MODIFICATIONS TO THE TUBE-LAUNCHED, OPTICALLY
TRACKED, WIRE-COMMAND MISSILE LAUNCHER FOR
THE BRADLEY FIGHTING VEHICLE SYSTEM

Report Number 98-165

Office of the Inspector General
Department of Defense

Figure 3. Umbilical Switch Specification

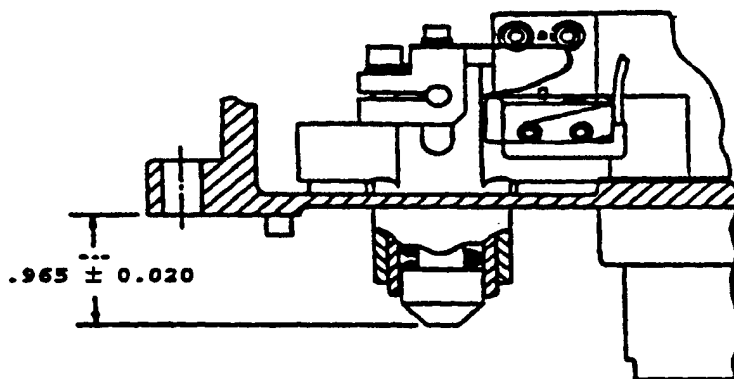
Alignment of Umbilical Switches. The DMWR requires the gauge set to align and test the ACU umbilical switches S1, S2, S3, and S4. Switches S1 and S2 are associated with the inboard launcher tube, while S3 and S4 are associated with the outboard launcher tube. The S2 and S4 switches, when activated, signal that a missile is present. The S1 and S3 switches, when activated, signal that a missile has been selected. According to the design specifications, those umbilical switches should be aligned to activate when the bottom of the holdback pin plunger is 0.965 inches, plus or minus 0.020 inches, from the bottom of the ACU housing as shown in Figure 3.

The S1 through S4 gauge assembly of the gauge set is used to measure the depth of the holdback pin plunger at the time the umbilical switches have been activated.

Figure 4. Holdback Pin Plunger Depth Specification

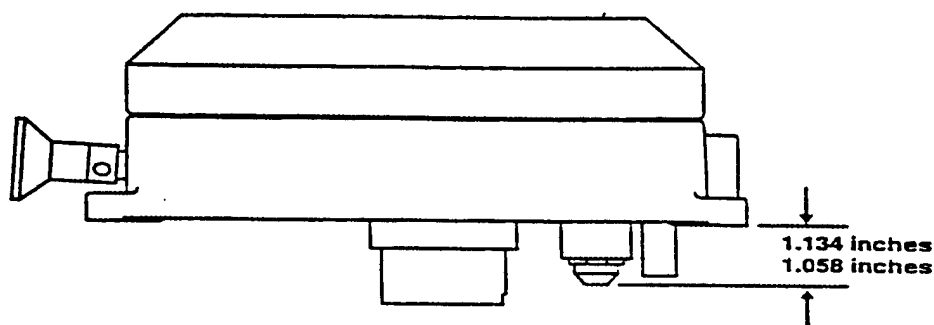
Alignment of Motor Stop Switches. The DMWR requires the gauge set to align and test motor stop switches S5 and S6. The S5 switch is the electrical limit switch for the extend function of the ACU motor. The S6 switch is the electrical limit switch for the retract function of the ACU motor. The S5 and S6 settings affect the distance that the holdback pin plunger and umbilical cable are extended when arming the system and retracted when disarming the system. The gauge set, specifically the S5 gauge assembly is required to ensure that the holdback pin plunger depth in relation to the ACU housing is between 1.058 inches and 1.134 inches, as shown in Figure 4, in order to satisfy design specifications.
